5. Zoning Case 19-10; LHB/Essentia Health, Site Plan

**ITEM DESCRIPTION: ZONING CASE 19-10: SITE PLAN LHB/ESSENTIA
CLINIC AT 1413 HIGHWAY 33 SOUTH**

MEMO

SUBJECT: Essentia Health Clinic– 1st Review

DRAWING TITLE:
GRADING PLAN

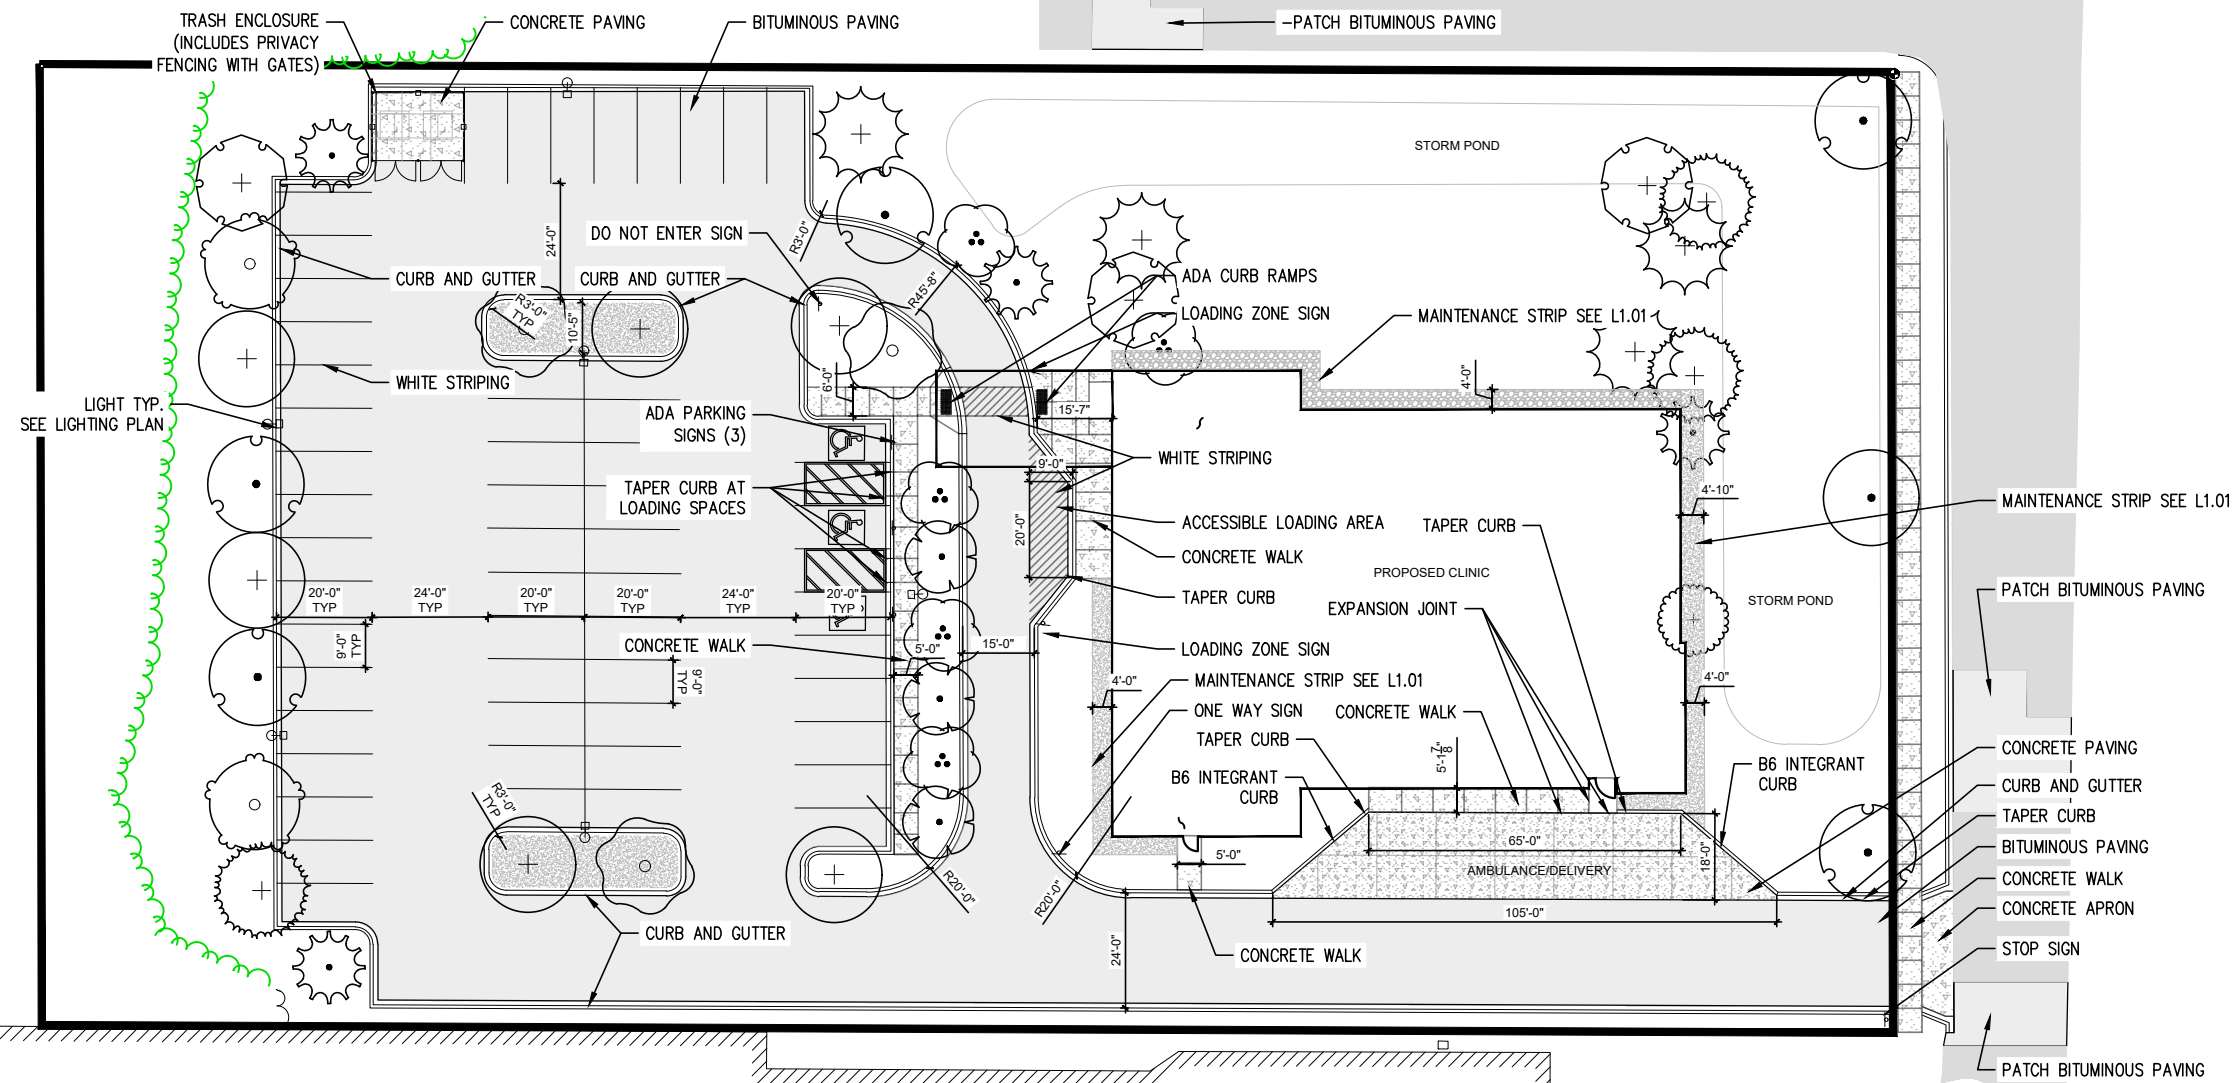
Grading Plan C3.01

10. Spot grades along Gillett Road have not been shown. The intent as we understand it is to follow the profile of the existing pavement with the new curb. A note should be added to make this clear
11. The 100 yr hwl of the pond should be labeled
12. The drainage along the north side of the pond appears to route surface drainage from the NAPA parking lot to the flared end section but no elevations are shown for this swale.
13. Grading in the MnDOT ditch will be necessary to get apron APR-301 to drain to the ditch shot of 1200.1 A MnDOT permit is needed for this work.
14. Type of plantings in the stormwater treatment area should be identified. Is this intended to be a turf grass area or will it have native deeper rooted plantings?

DRAWING TITLE:
**SURFACING AND
 LAYOUT PLAN**

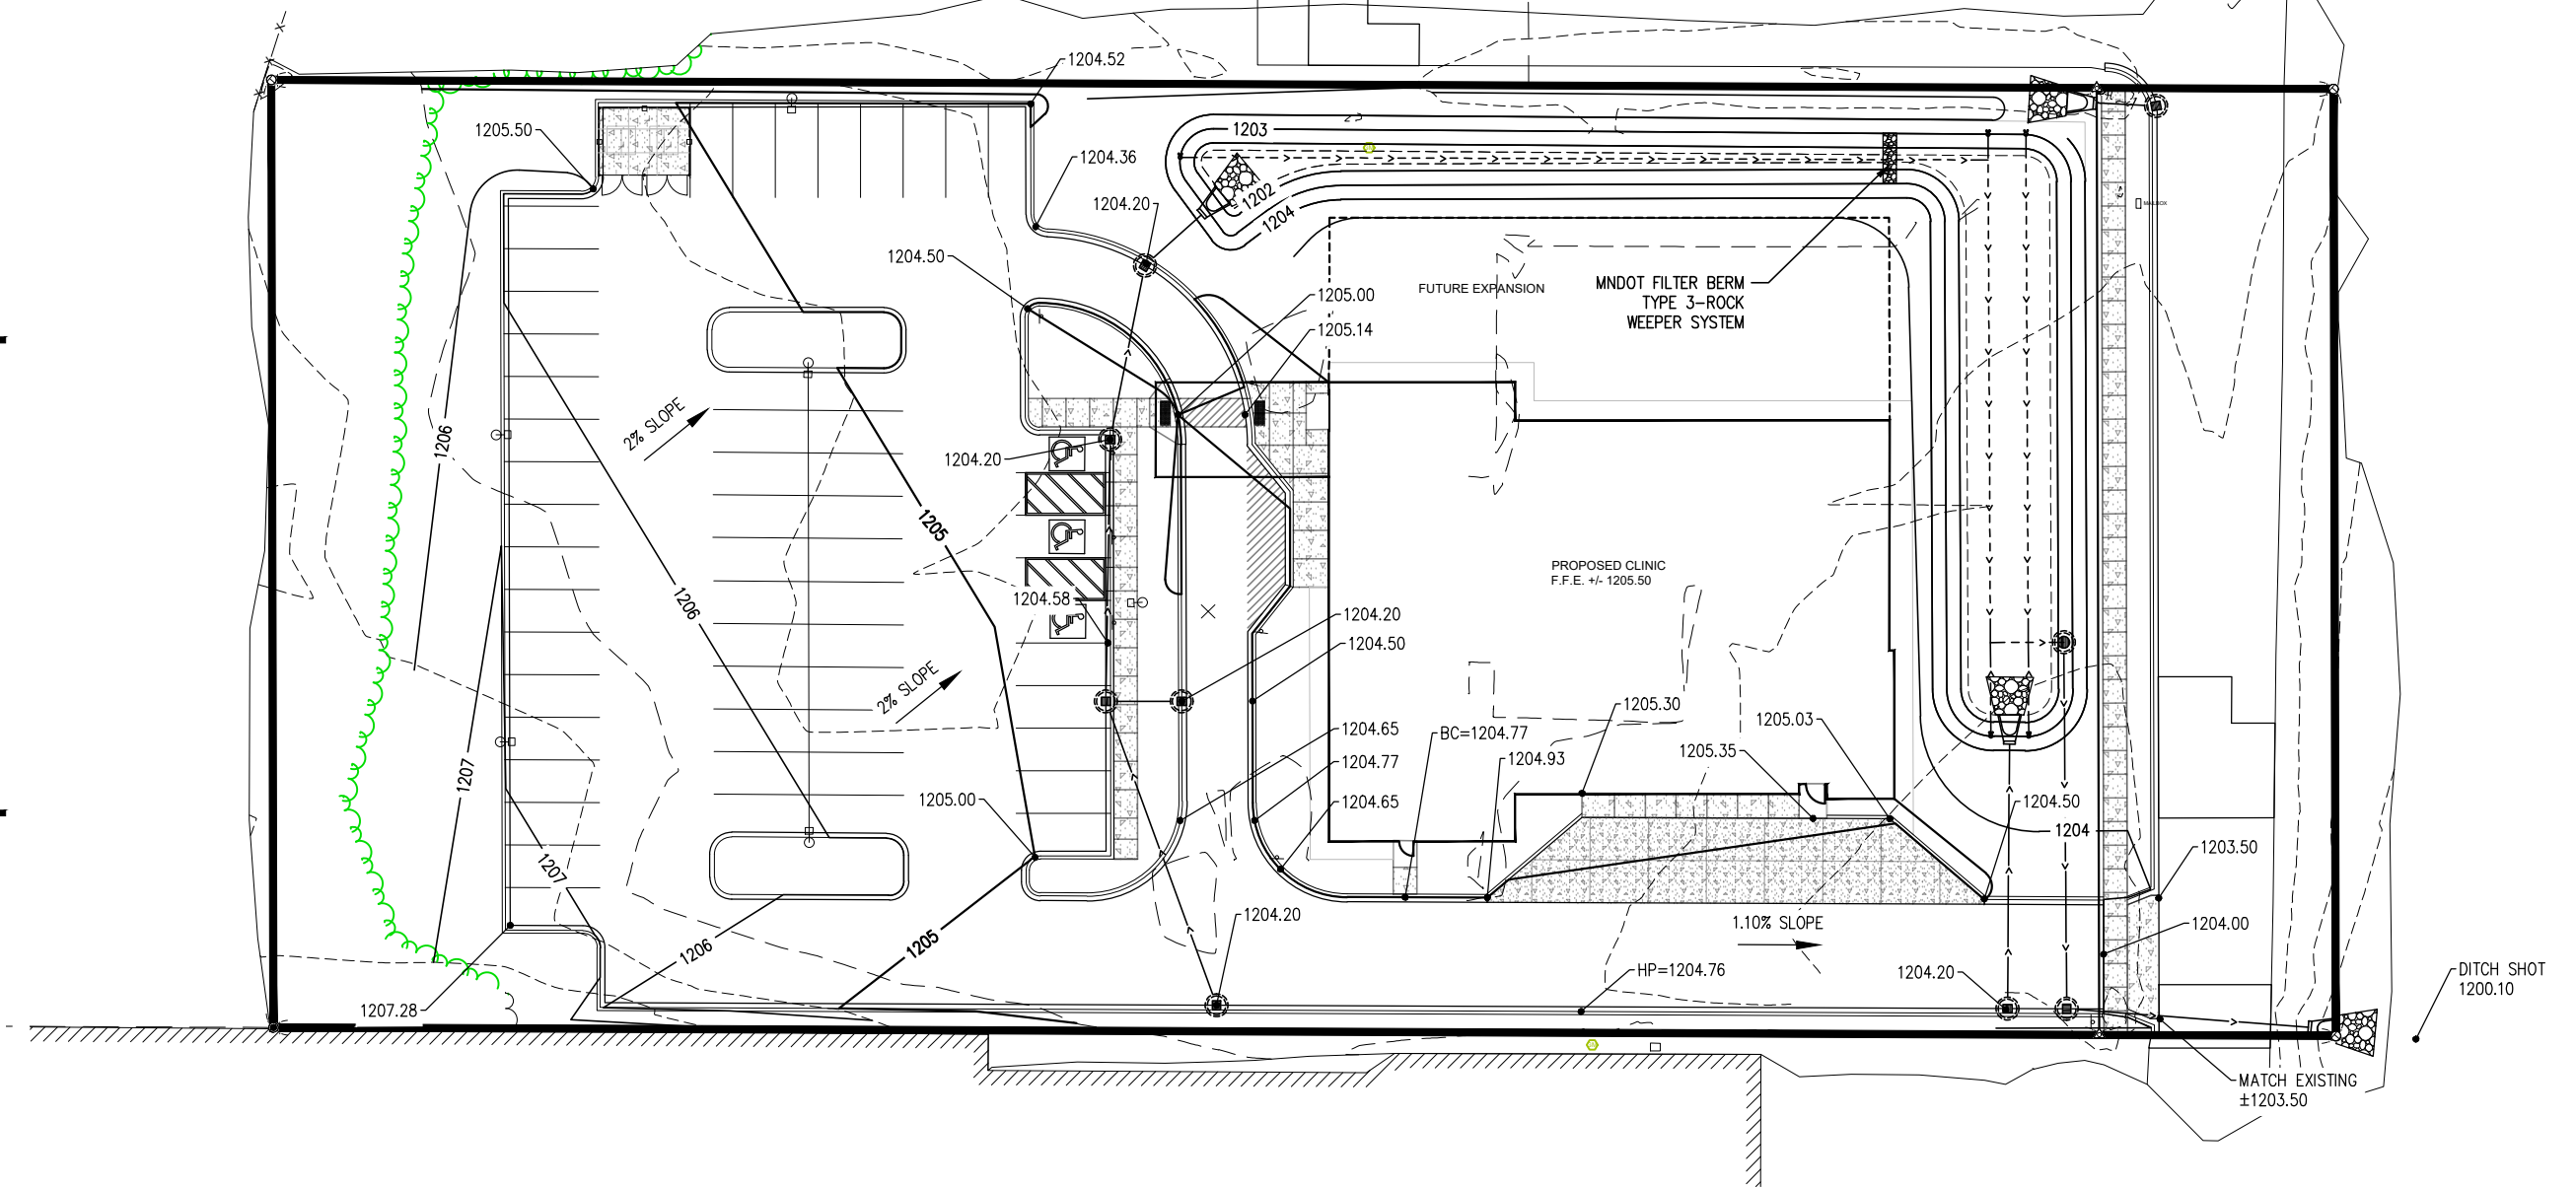
Surfacing and Layout Plan C4.01

15. Width of Gillett Road to Back of curb, boulevard and side walk should be shown.
16. Sidewalk along Gillette Road at north end appears to be close to the existing power pole.
17. Sidewalk along Gillette Road at the north end should extend to the new curb.
18. The plan should identify the curb along Gillette Road to be B618 style

DRAWING TITLE:
UTILITY PLAN

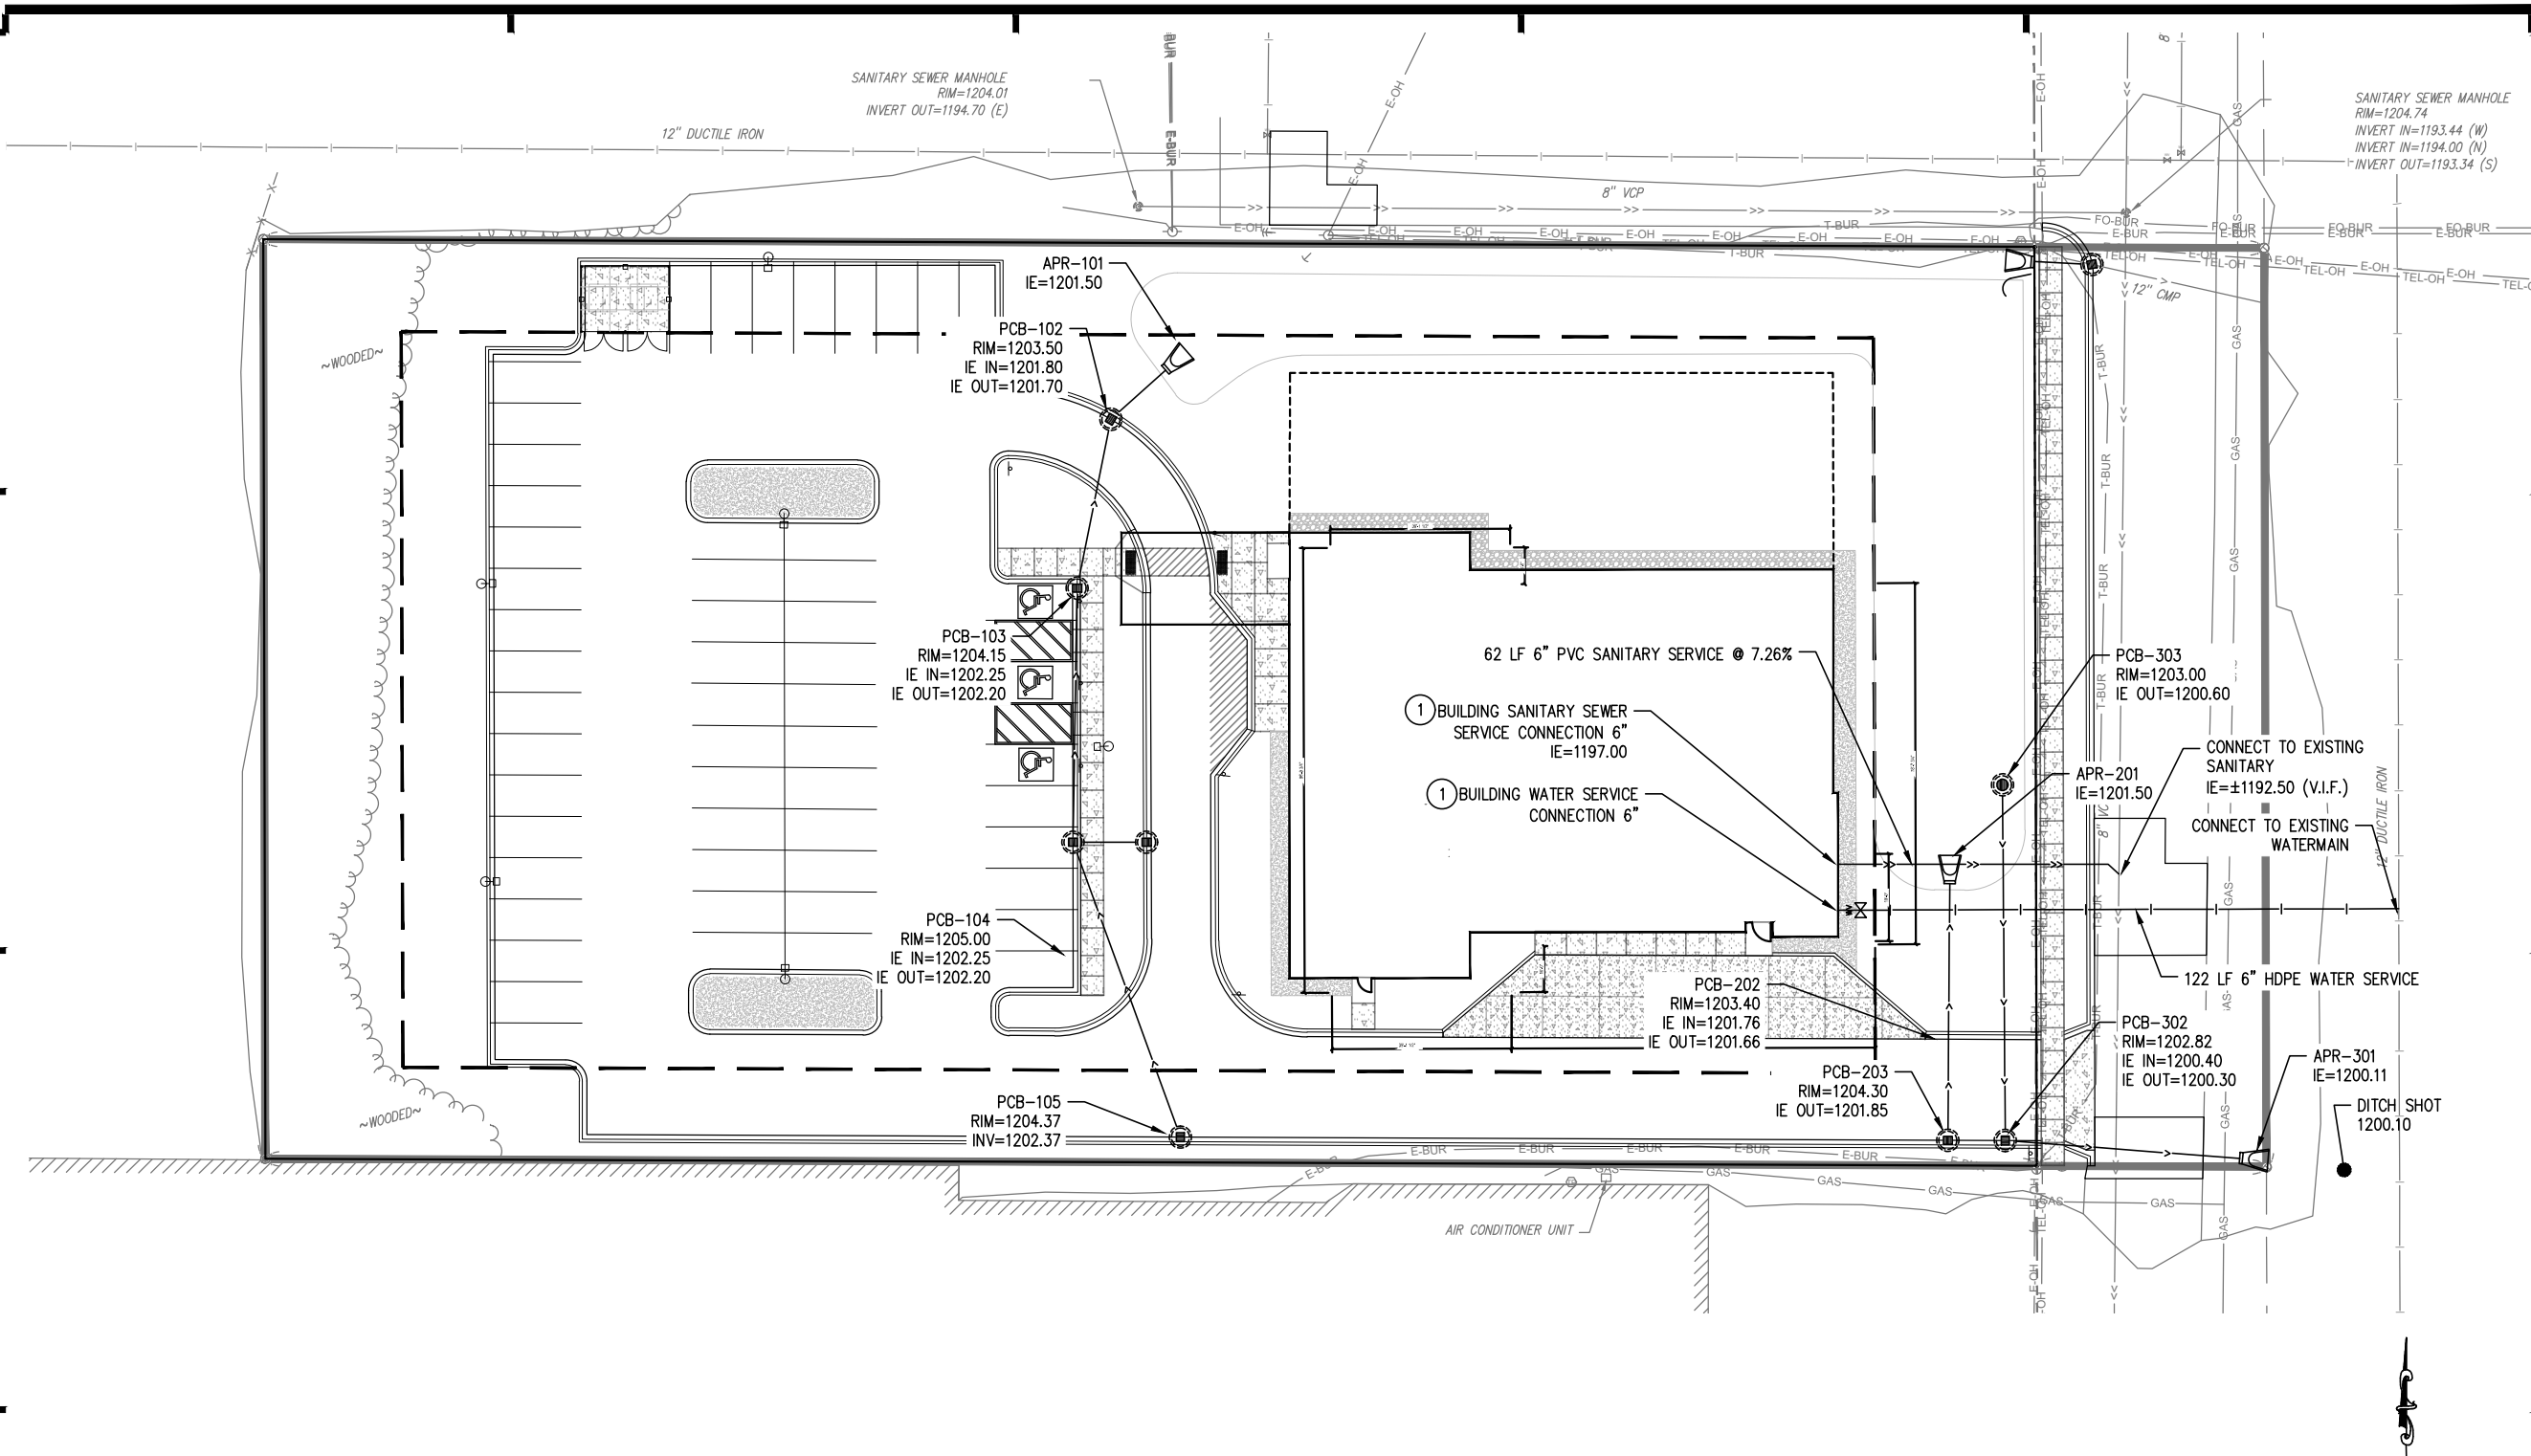
Utility Plan C5.01

19. Water service should be shown to be wet tapped on the main with a 6 inch gate valve at the tap location. Additional valve at the building as shown is not needed.
20. A MnDOT permit will be required for the water connection in the MnDOT ROW
21. Water service will be under storm sewer open to the north which may be susceptible to cold air intrusion and deeper than normal frost. Consider insulating or relocating.
22. Sanitary sewer service has only 4 to 5 feet of cover where it crosses the storm sewer apron. Consider relocating it further south or insulating it.
23. A sewer connection permit from the City of Cloquet will be required for this work
24. A water service connection permit from the city of Cloquet will be required for this work.

25. Tracer wire along with ground rods, access boxes in accordance with Minnesota Rural Water standards should be installed along with sewer and water services.

26. The plans should identify the catch basin casting type along Gillette Road to be R-3067-V
27. The existing culvert at the north east corner of the site should be replaced with a new 12" HDPE or CMP pipe crossing Gillette Road

28. The size slope and pipe materials are not shown on the utility plan, please included them.
29. Storm sewer structure sizes and castings are not identified in the plan.

30. Riprap is needed at all storm sewer outlets.
31. A plumbing permit from the Minnesota Department of Labor and Industry or Dept of Health will be required for the sewer, water and storm sewer on this site.
